SUBJECT: INDEPENDENT QUALITY REVIEW GROUP COMMENTS ON THE ABB-COMBUSTION  
ENGINEERING (ABB-CE) SYSTEM 80+ CERTIFIED DESIGN MATERIAL (CDM) AND  
ABB-CE STANDARD SAFETY ANALYSIS REPORT (CESSAR-DC)

An Independent Quality Review Group has reviewed the CDM and the CESSAR-DC, and provided their comments to the staff inspections, tests, analyses, and acceptance criteria (ITAAC) task groups. The ITAAC task groups have reviewed the comments, and those that require action by ABB-CE are contained in the enclosure.

FIGURE 2.4.5-1 (PAGE 1 OF 4)  
CONTAINMENT ISOLATION VALVE CONFIGURATION

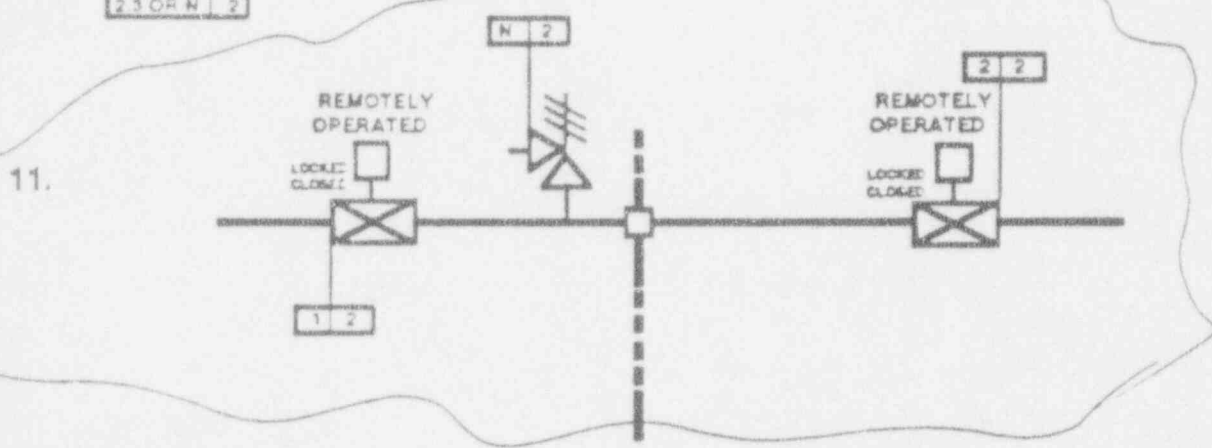
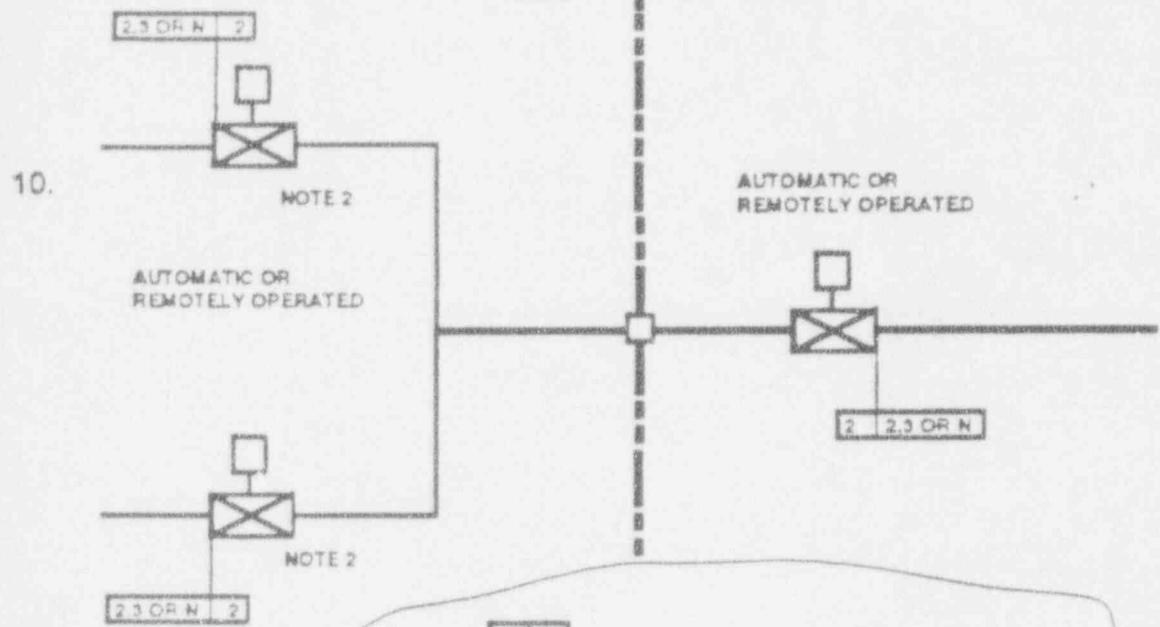
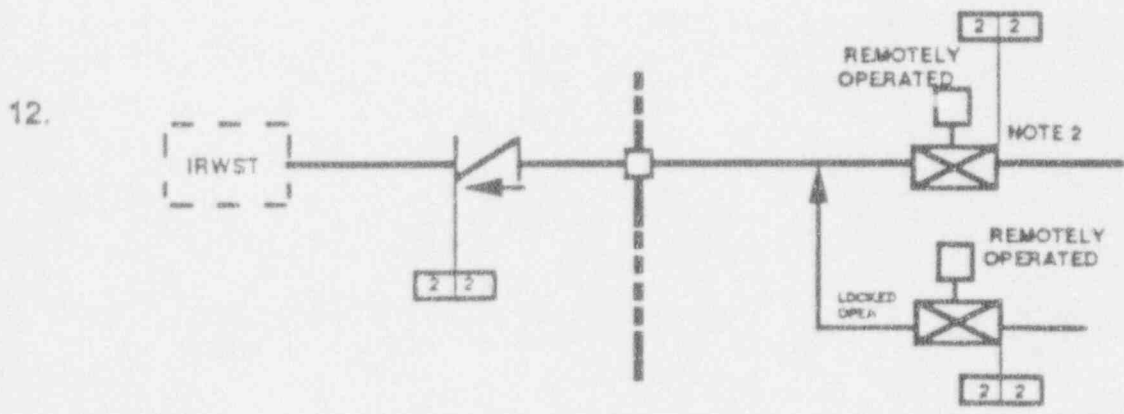
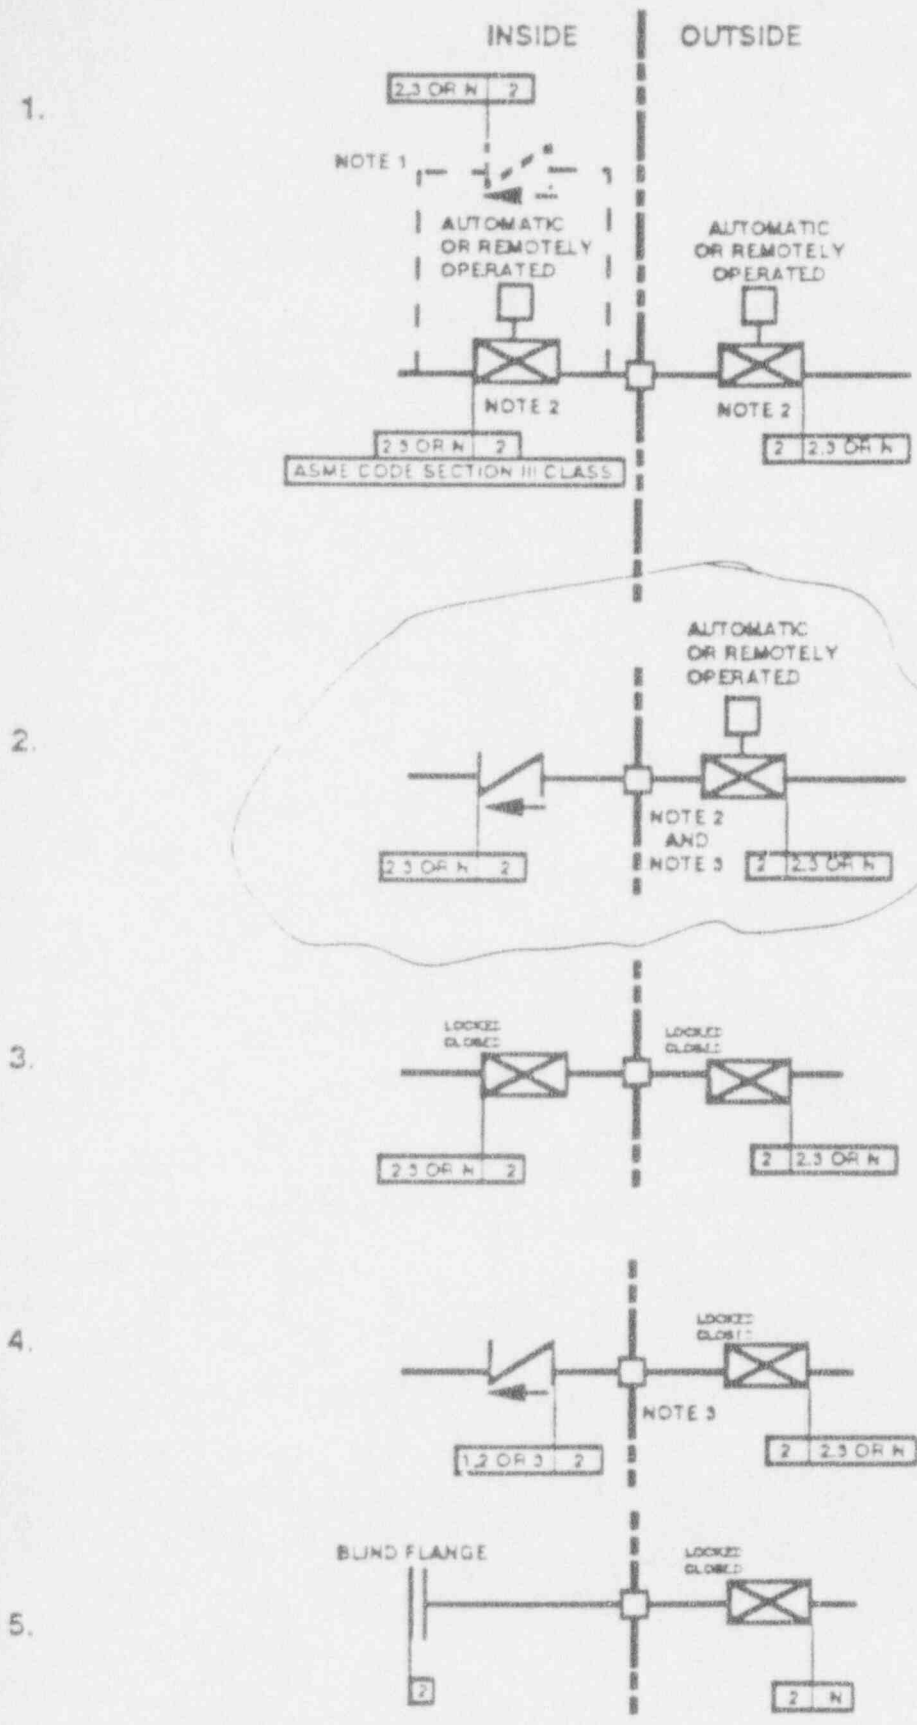
No.	Comments	Cat.	Resolution
6	Table 2.4.5-2 Items 19 & 20 corresponding to Figure 2.4.5-1 Arrangement 2: the inside containment check valve is shown as ASME Section III Code Class 2 whereas CESSAR Figure 6.3.2-1C is showing Code Class 1. Please resolve this discrepancy.	1	<i>Agree</i>
7	Intentionally Blank.		
8	Table 2.4.5-2 Item 52 corresponds to CESSAR Table 6.2.4-1 Item 57, which is identified as a part of CESSAR Figure 9.3.2-1. This item cannot be located on the above figure.	1	<i>Agree</i>
9	CESSAR Table 6.2.4-1 Item 53 is shown as "INTENTIONALLY BLANK", whereas on Figure 9.3.2-1 its the Containment Penetration between valves SS-235 and SS-236.	1	<i>Agree</i>
10	Table 2.4.5-2 Items 53 to 58 inclusive corresponding to CESSAR Table 6.2.4-1 Items 58 to 63 inclusive need a drawing/figure reference, currently none is available. Furthermore, valves SS-220 to SS-227 inclusive can be found on CESSAR Figure 9.3.2-1 but are not associated with any containment penetrations. Please resolve this confusion.	1	<i>Agree</i>

CESSAR  
FIGURE 9.3.4-1  
SHEET 2 OF 4

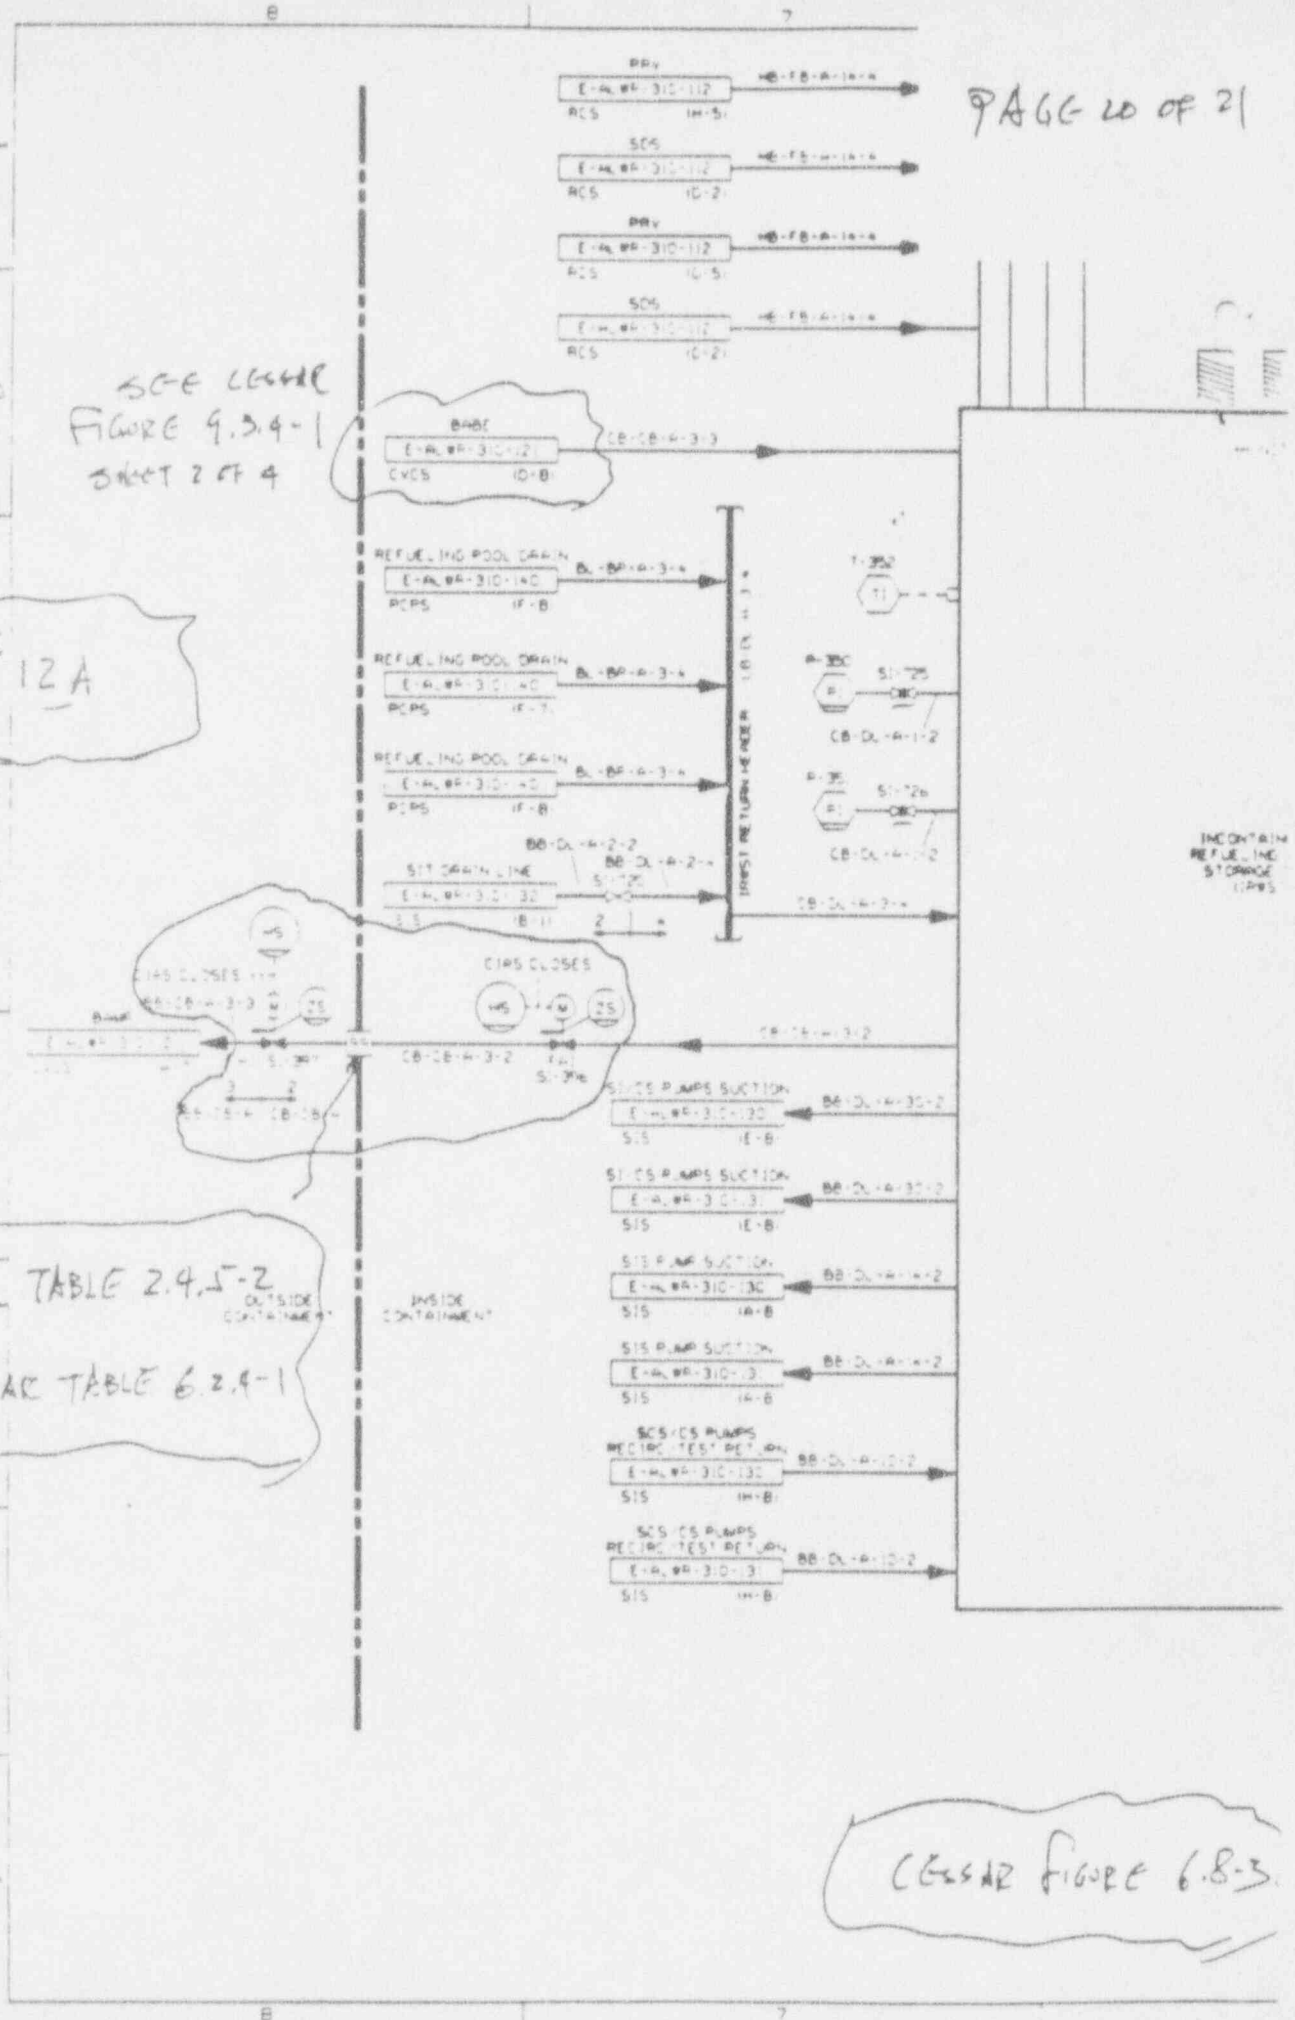
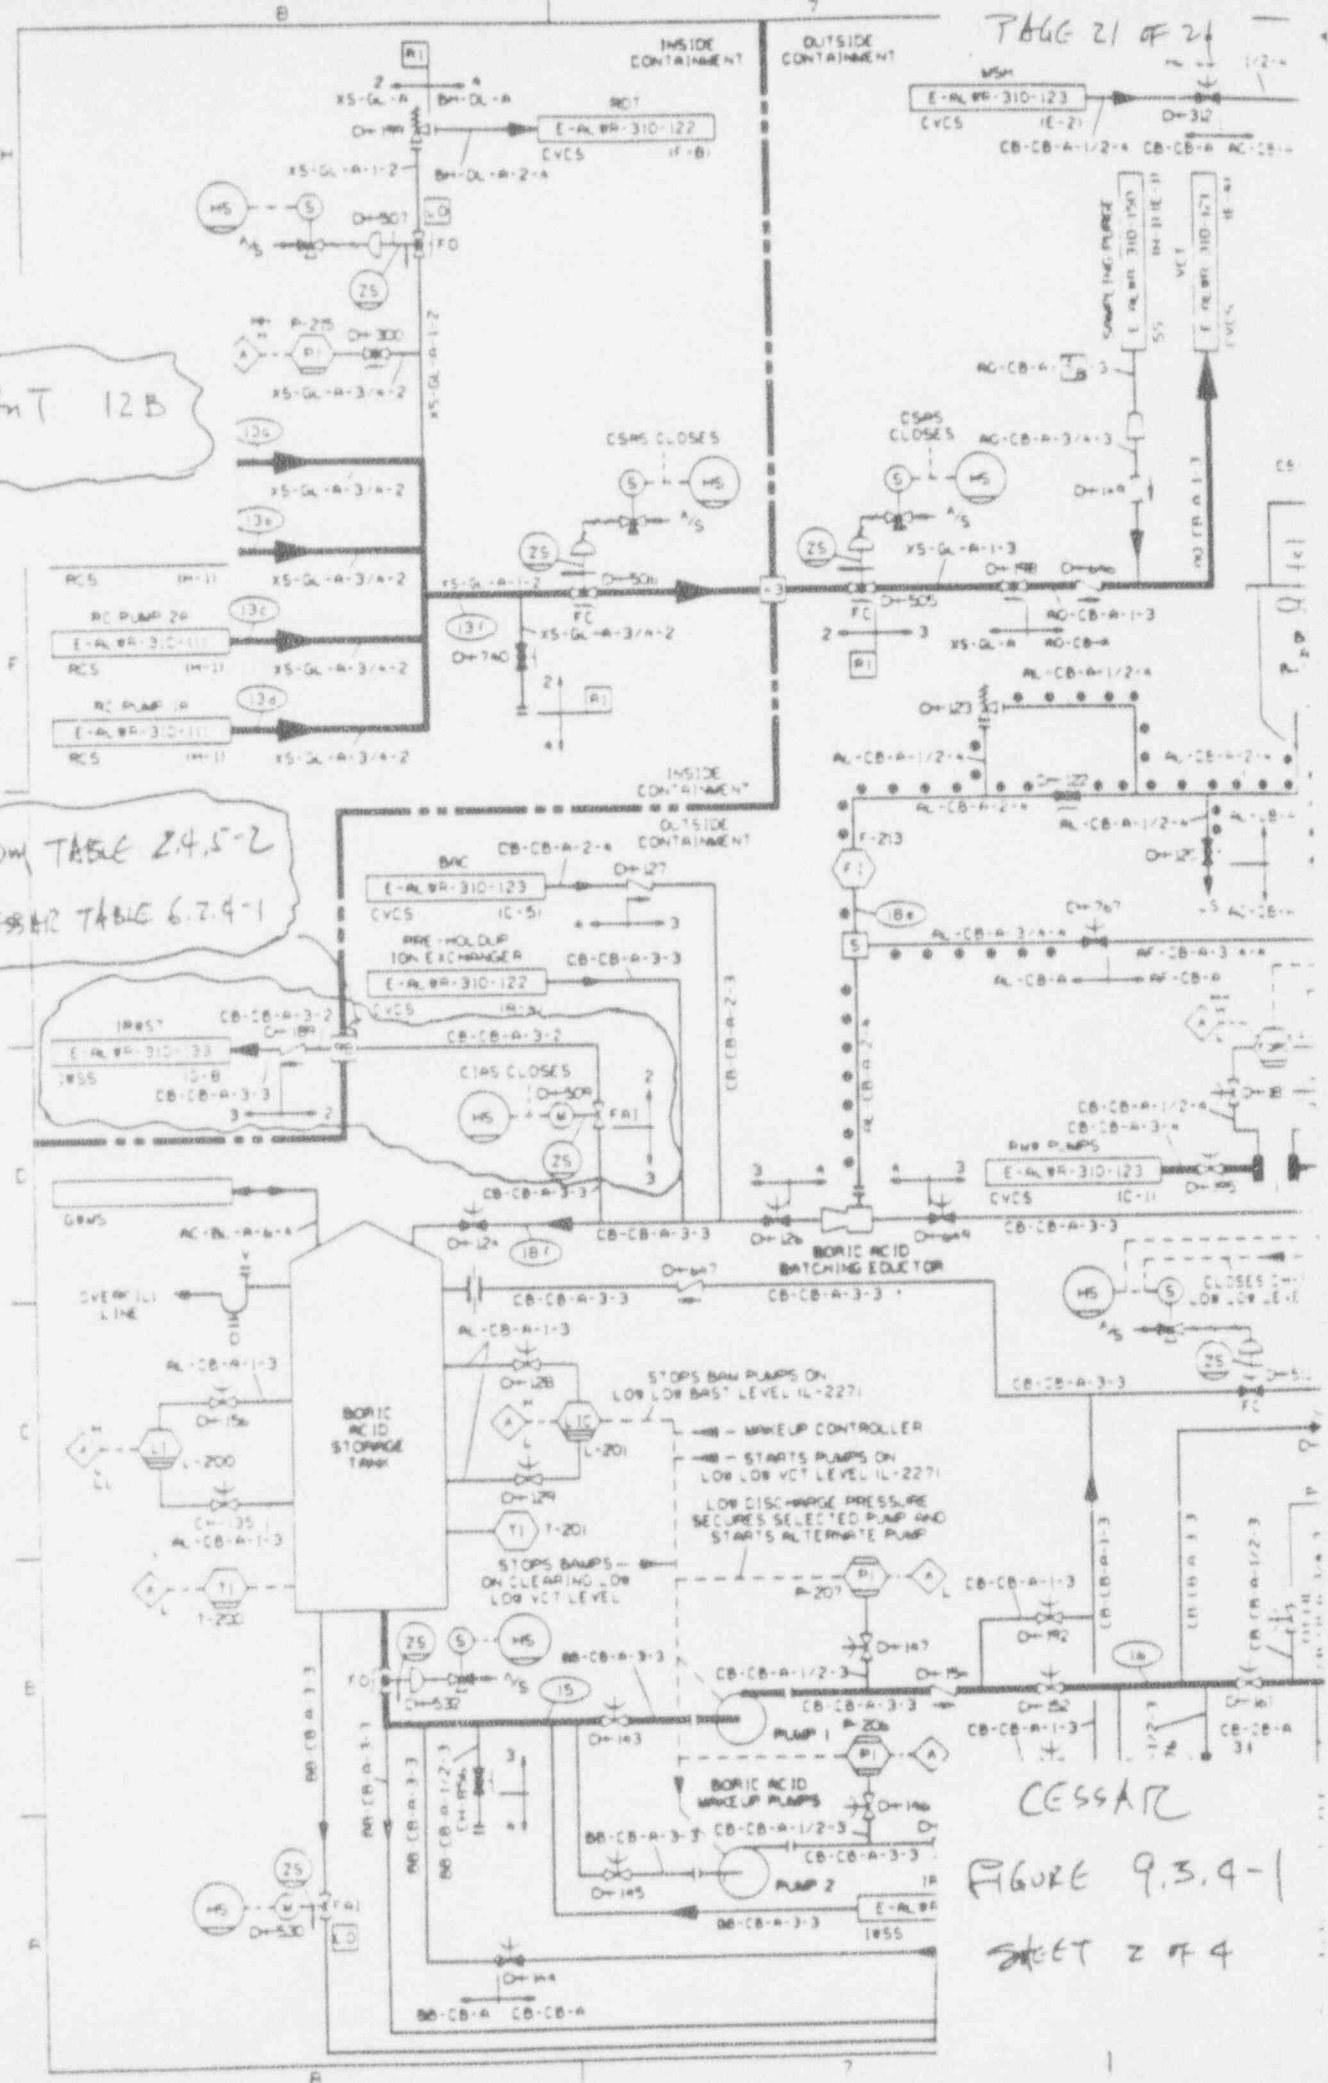
No.	Comment		
11	See attached pages 17 to 19 for typos.	1	<i>Agree on page 17 &amp; 18. Disagree on page 19.</i>
12	Table 2.4.5-2: A) Item 90, this is Item 36 of CESSAR Table 6.2.4-1, and Containment Penetration 99 of Figure 6.8-3. B) Item 91, this is Item 38 of CESSAR Table 6.2.4-1, and Containment Penetration 98 of Figure 9.3.4-1 sh 2 of 4. Please resolve these discrepancies.	1	<i>Agree</i>
13	Table 2.4.5-2 item numbers corresponded to the Containment Penetration Numbers similar to CESSAR Table 6.2.4-1 up to and included Item 35. Item numbers greater than 35 are no longer in agreement. The deviation of higher numbers must be resolved so that the correspondence is reestablished for all of the CDM item numbers to penetration numbers.	1	<i>Agree</i>
14	A statement of purpose for Table 2.4.5-2 in the text portion of the CDM similar to that of Figure 2.4.5-1 and Table 2.4.5-1 is needed.	1	<i>Agree</i>
